City of Portsmouth
Department of Public Works

Bid Proposal #30-06
Shoreline Repairs Prescott Park and Four Tree Island
Addendum #1
January 27, 2006

PRESCOTT PARK SITE PLAN

PRESCOTT PARK AND
FOUR TREE ISLAND
SHORELINE REPAIRS

PRESCOTT PARK SECTIONS

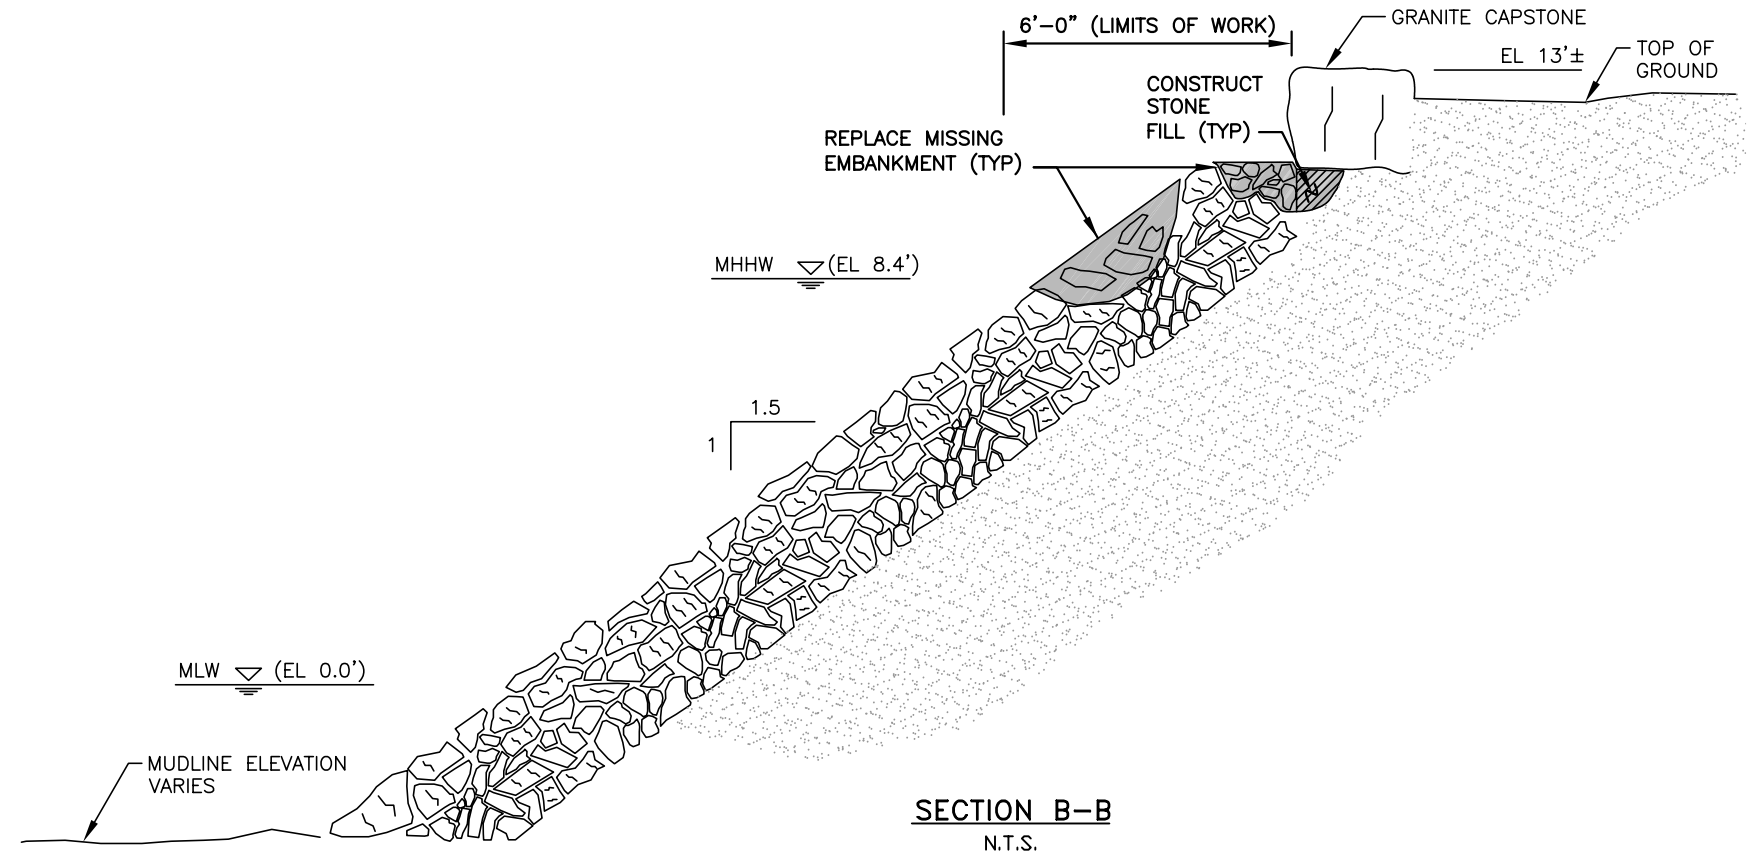
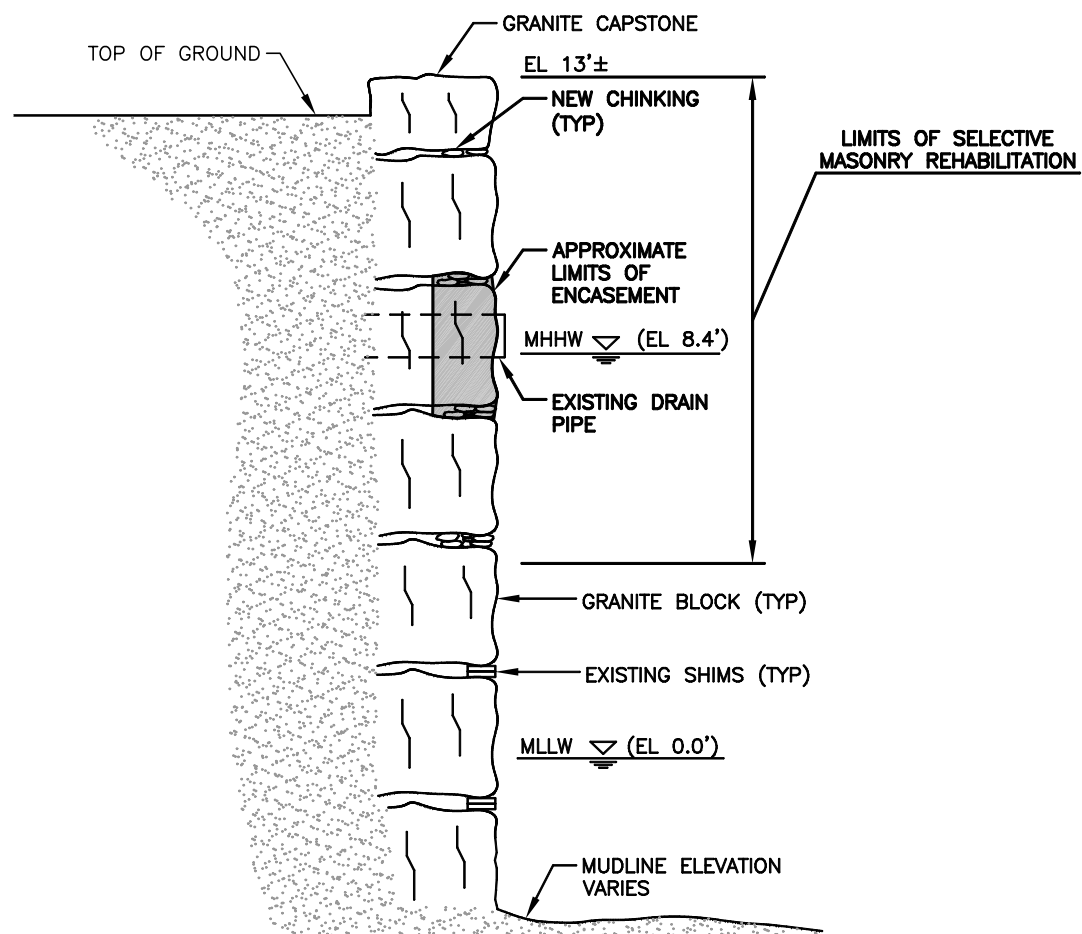
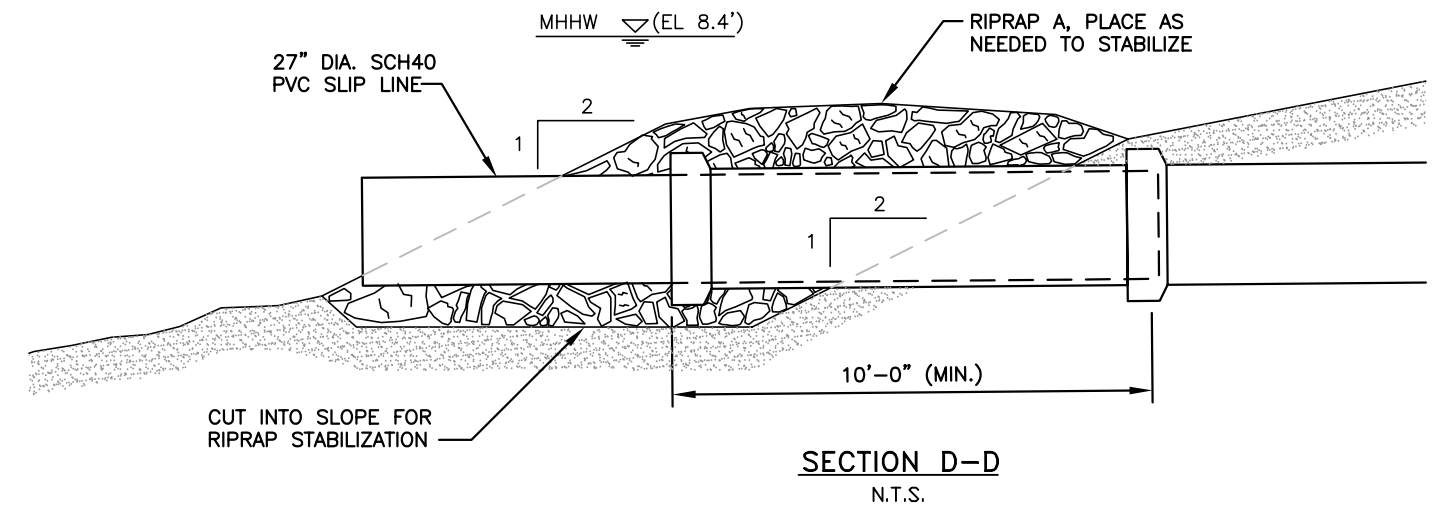
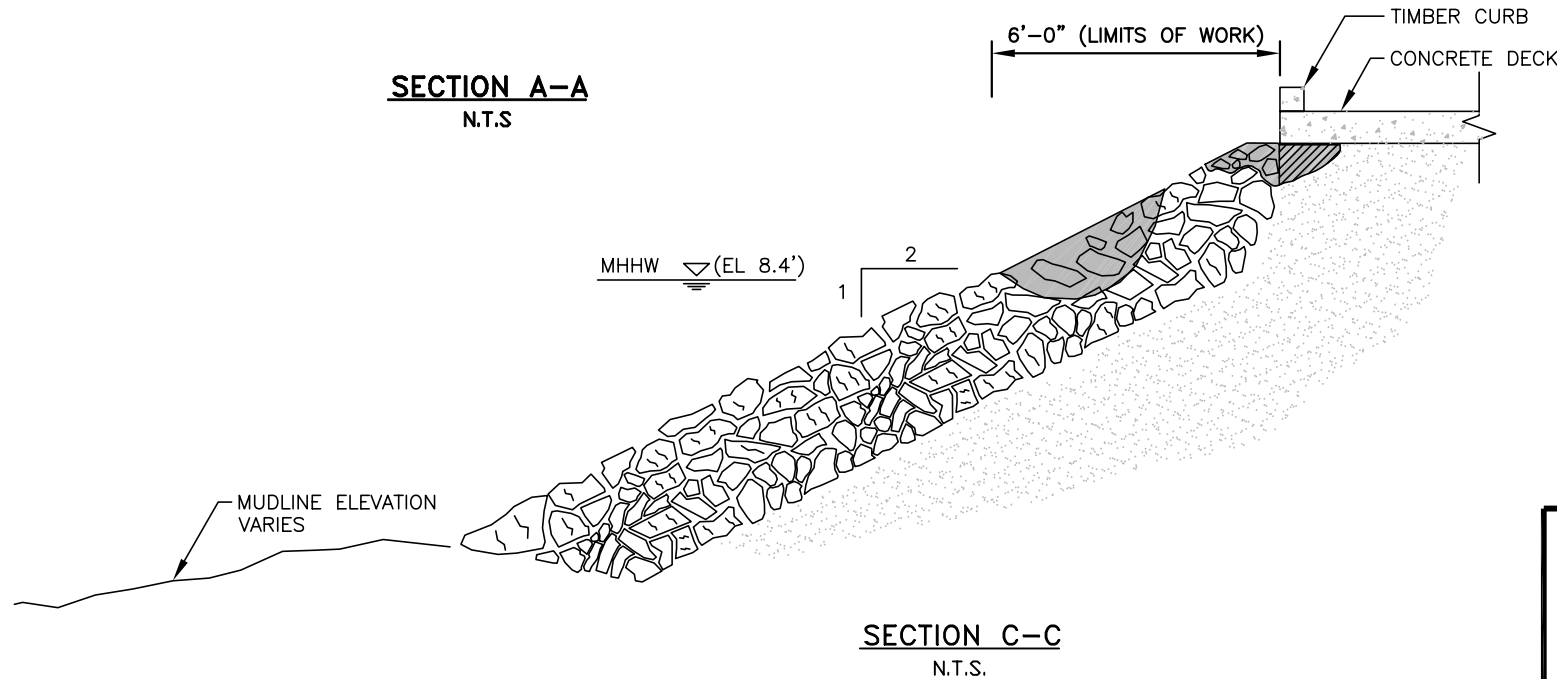
1. Excavate old 30" CI drain pipe from where it exits the ground at approximately mid-tide level to its termination near the end of the existing pier. (Approximately 100 LF)
2. This new termination shall be slip-lined with a 27" PVC pipe and mortared in place for a minimum length of 10'. Contractor to confirm the pipe size.
3. Rip Rap Class A shall be placed around the new out-fall to stabilize the structure in accordance with the Standard Details Sheet 2 of 3 entitled Prescott Park Sections.
